# Service Bulletin

Bulletin No: 31 001 02 (043)

**Subject:** Technical Action: Replacement of bolt in the fork stabilizer - F 650 Dakar models only.

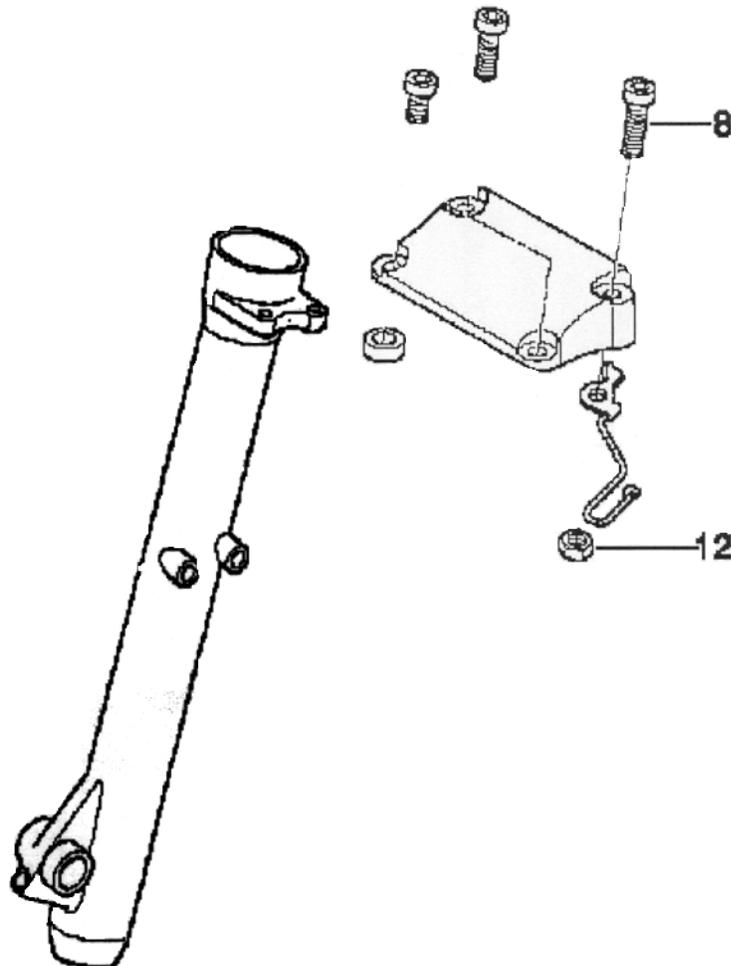
**Details:** We have been notified by Showa, the manufacturer of the front forks for the F 650 Dakar model, that one of the four mounting bolts, attaching the fork stabilizer to the fork legs is incorrect.

The shank on the incorrect bolt is too long and may not hold properly, even though it was installed to the correct torque.

It is possible that the brake hose holder that is held in place by this bolt may work loose over time.

**Production Solution:** Installation of a shorter mounting bolt. The nut of the brake hose holder is now secured with Loctite.

**Service Solution:** Remove the mounting bolt (#8 in the illustration below) replacing it with the M8x40 bolt included with this bulletin. Tighten this bolt to 20 Nm.

Install the brake hose holder and securing nut (#12 in the illustration below). Use Loctite 2701 and a tightening torque of 8.5 Nm for this installation.
